Re: Moffett Park Area Specific Plan Draft
Miramar Residential Project
352 E. Java Drive

DRAFT ENVIRONMENTAL IMPACT REPORT FOR MOFFETT PARK SPECIFIC PLAN
– DATED DECEMBER 2022 (STATE CLEARINGHOUSE NUMBER: 2021080338)

Re: Comments on Draft Moffett Park Specific Plan

Figure 1: Zoning Map, page 81 from the Draft Moffett Park Specific Plan dated December 2022

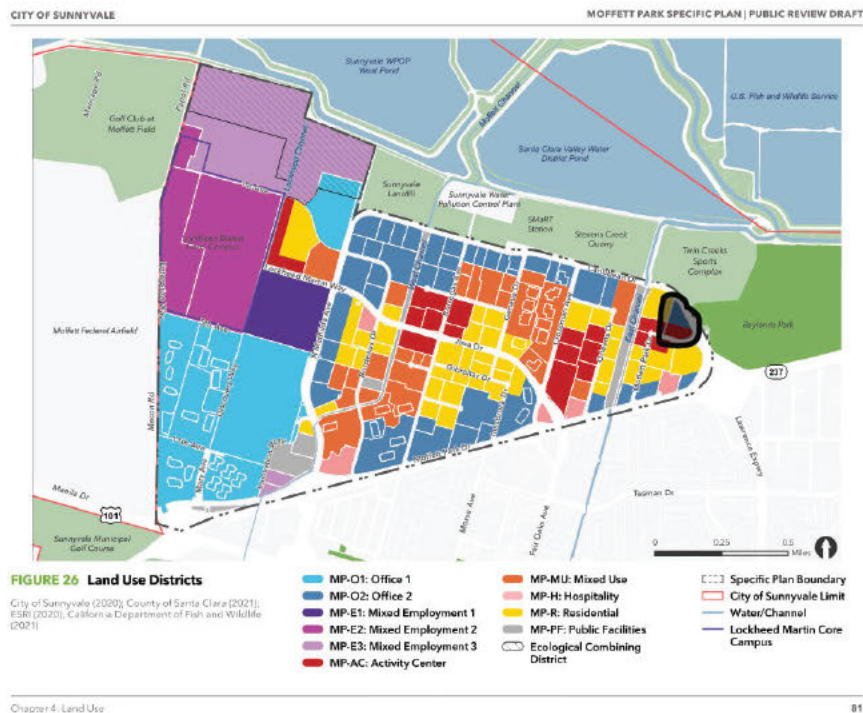
Per the Draft MPSP released in December of 2022, the Subject Site is proposed to be zoned with a mix of Activity Center, MP-AC, and Office 2, MP-O2. See Figure 1 below.

Based on our discussions with you and your colleagues, we understand that the split zoning was approximately measured by lining up the property line between the adjacent properties, APN 110-37-003 and 110-37-001, ~254.5' from our southern property line. This results in ~123,000sf being zoned as MP-AC and ~140,000sf being zoned as MP-O2.

Excerpt of Segment O, USFWS Recovery Plan for Tidal Marsh Ecosystems, Figure 111-21. Red line marks approximate inland limit for potential restoration.

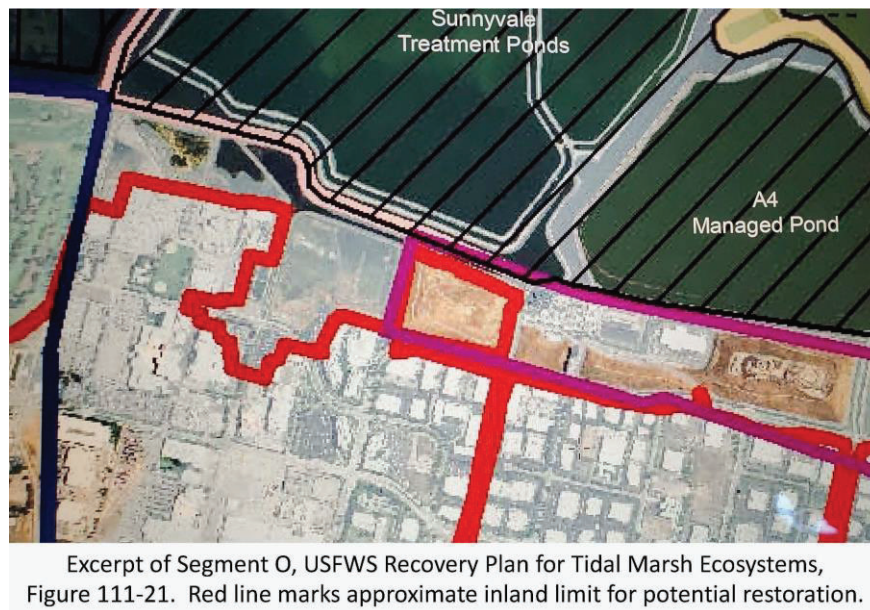
Area of the Midpeninsula Regional Open Space District (Midpen).³ The DEIR should refer to the USFWS 2007 Recovery Plan for the Western Snowy Plover⁴ for guidance for potential recovery actions in the MPSP Area.

PROPOSED SEASONAL LEVEE CLOSURES

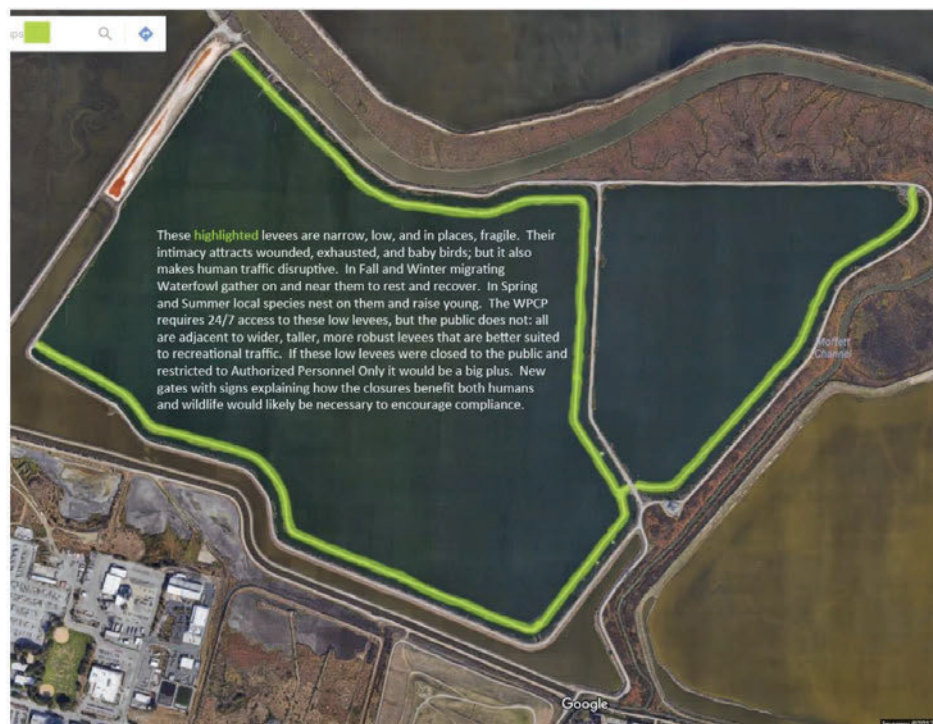
- Ensure that night lighting is avoided, and not added to trails on levees, near wetlands, or on and around the landfill hills,
- With the exception of commute trails (Such as Bay Trail and the East and West Channels trails), limit access to human-powered-only, and prohibit electronic or motorized mobility devices,
- Limit public access to some of the Baylands Levees. Sunnyvale resident and naturalist Kira Od provided the attached report¹² in which she identifies parallel levees that can be closed to public access with no impact to mobility and circulation (Figure 2). Ms. Od's comments and recommendations can be integrated into the EIR to mitigate some of the impacts of human encroachment and disturbance of wildlife and habitat,

Figure 3. TCE shallow groundwater plume overlaid on DEIR Proposed Land Use Map

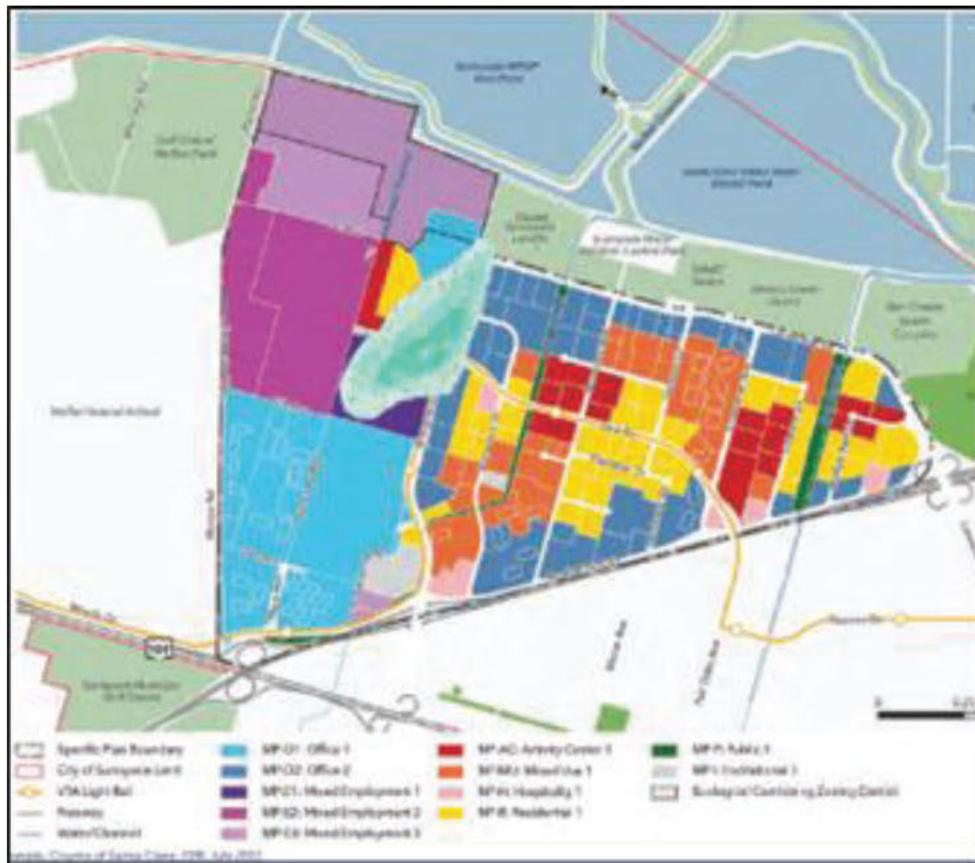
Residential use is not advisable for project parcels that have volatile organic compounds (VOCs) in groundwater or soil vapor far in excess of California Environmental Screening Levels (ESLs). The Proposed Land Use Map (MPSP DEIR Figure 2.3.1) shows a residential area between Lockheed Martin Way, 1st Avenue and Bordeaux Drive. A portion of this parcel is located above a groundwater solvent plume from the Lockheed Plant One/Naval Industrial Reserve Ordnance Plant (NIROP) military cleanup site.²⁹ Figure 1 shows the trichloroethene (TCE) groundwater plume from the Figure 2-15 of the NIROP report, overlaid on the Project Land Use Map. Soil gas samples within the proposed residential area have concentrations greater than USEPA ESLs for the carcinogens TCE, vinyl chloride (VC), benzene, and chloroform, contributing to an estimated lifetime excess cancer risk for residential use of greater than one in one million.

Subslab soil gas and indoor air sampling has found VOC concentrations in excess of USEPA commercial use SLs at multiple vacuum degreaser facilities within the Lockheed Plant One site and within the boundaries of the NIROP solvent plume,³⁰ and in the vicinity of the Google Caribbean Campus.³¹ This is not a complete list of sites in the project area that could potentially have soil gas contamination. Other potential areas with known or suspected hazardous chemical releases were identified in the Farallon Consulting report, Appendix F to the Draft EIR.³² Subsequent projects should perform soil gas sampling at potential contamination sites.

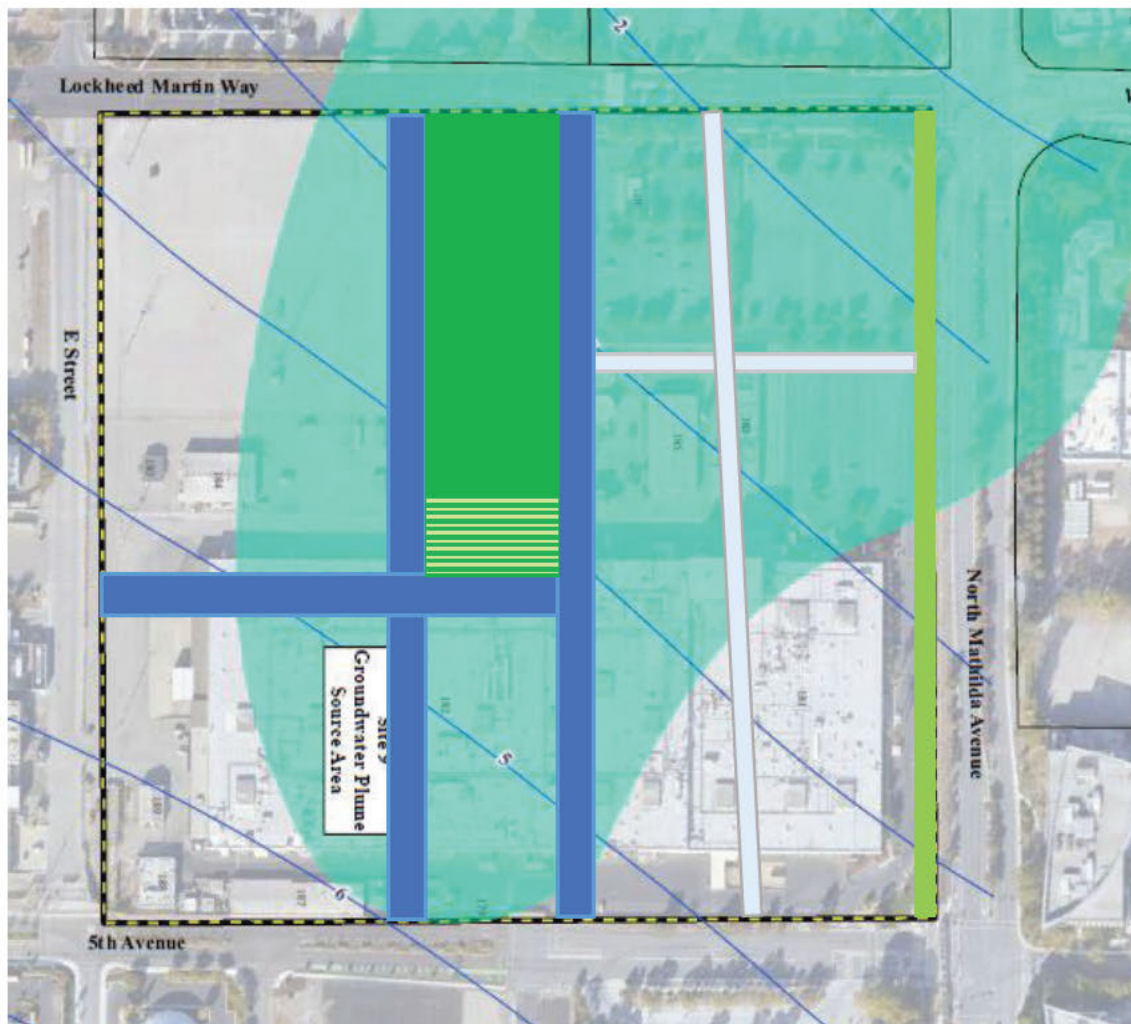
7	7.2	Pg. 187	<u>Complete Streets Typology and Network</u> Figure 43 – Conceptual Vehicular Street Network	The Navy requests flexibility in placement of these roadways and laneways to accommodate Navy cleanup activities and maximize size of future developable areas while maintaining the goal of “walkable neighborhoods” as mentioned in Section 3.7 (pg.51)
7	7.2	Pg. 188	<u>Complete Streets Typology and Network</u> Figure 44 – Complete Conceptual Street Framework	The Navy requests flexibility in placement of these roadways and laneways to accommodate Navy cleanup activities and maximize size of future developable areas while maintaining the goal of “walkable neighborhoods” as mentioned in Section 3.7 (pg.51)
7	7.4	Pg. 205	<u>Bicycle Network</u> Figure 57 – Complete Bicycle Network	The Figure depicts a Bicycle Lane along/near the western border of the Navy parcel. Navy requests flexibility to move this Bicycle Lane to the Eastern border of the parcel that would be parallel to the VTA railway. This move would

coincide with the cleanup efforts currently underway by Navy. Please refer to the Navy supplied "Navy Parcel Alternative Conceptual Layout Figure."
8	8.3.1	Pg. 226	<u>Vehicle Parking Maximums Standards</u> 1. Parking maximums. All new development shall adhere to the maximum parking requirements in Table 24. A project may exceed that maximum by up to 50% of the maximum ratio, provided that all of the additional spaces over the maximum shall be shared with the public at all times.	The Navy requests the statement "A project may exceed that maximum by up to 50% of the maximum ratio, provided that all of the additional spaces over the maximum shall be shared with the public at all times," be revised to "A project may exceed that maximum by up to 50% of the maximum ratio, provided that all of the additional spaces over the maximum shall be shared with the public at <i>specified times agreed upon by the City Council and landowner through the Development Agreement.</i> " This would allow for shared parking during evenings, weekends and holidays and other times as negotiated, but still maintain a higher than 2/1,000 sf parking ratio in the early adoptive years of the plan.

PROPOSED SEASONAL LEVEE CLOSURES

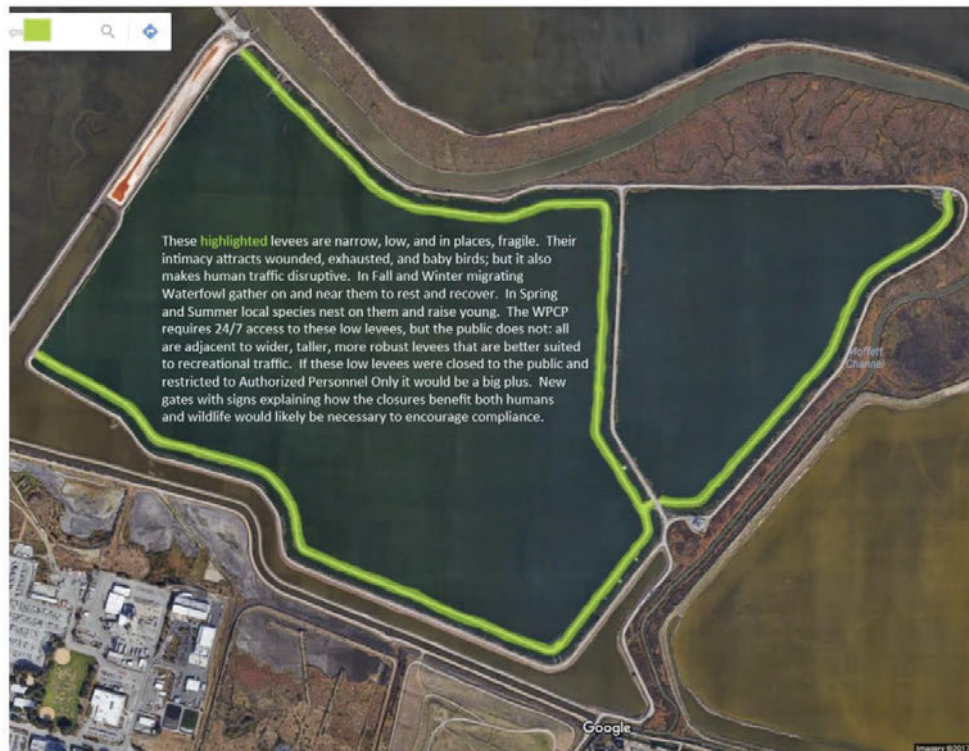
- Proposed new requirement 10.3.5-xx: Limit public access to some of the Sunnyvale Baylands Levees. Closing some levees to recreational activities (see Figure 1, below, levees proposed for closure to recreation are marked in Green). This mitigation measure reserves some levees for use by migratory birds while at the same time providing accessibility and connectivity for people. It reduces encroachment and disturbance of migratory birds.
- Proposed new requirement 10.3.5-xx: With the exception of commute trails (such as Bay Trail and the East and West Channels trails), limit access to human-powered-only, and prohibit electronic or motorized mobility devices except as required for Americans with Disabilities Act accommodation. This mitigation measure reduces encroachment pressure further from the Bay Trail.

PROPOSED SEASONAL LEVEE CLOSURES

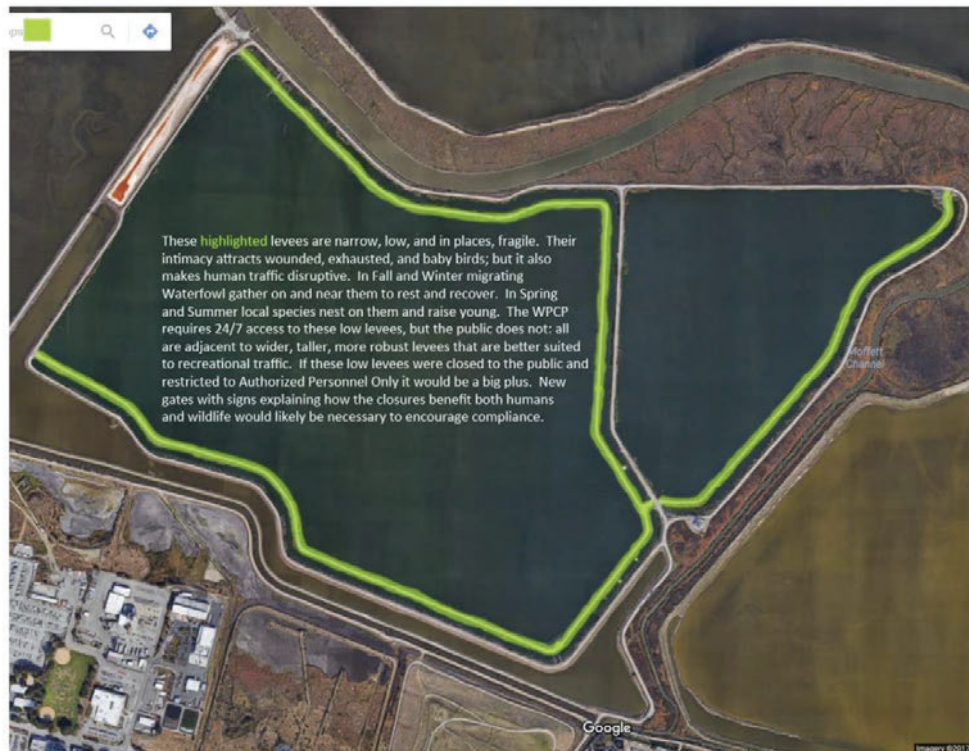
- Proposed new requirement 10.3.5-xx: Limit public access to some of the Sunnyvale Baylands Levees. Closing some levees to recreational activities (see Figure 1, below, levees proposed for closure to recreation are marked in Green). This mitigation measure reserves some levees for use by migratory birds while at the same time providing accessibility and connectivity for people. It reduces encroachment and disturbance of migratory birds.
- Proposed new requirement 10.3.5-xx: With the exception of commute trails (such as Bay Trail and the East and West Channels trails), limit access to human-powered-only, and prohibit electronic or motorized mobility devices except as required for ADA accommodation. This mitigation measure reduces encroachment pressure further from the Bay Trail.
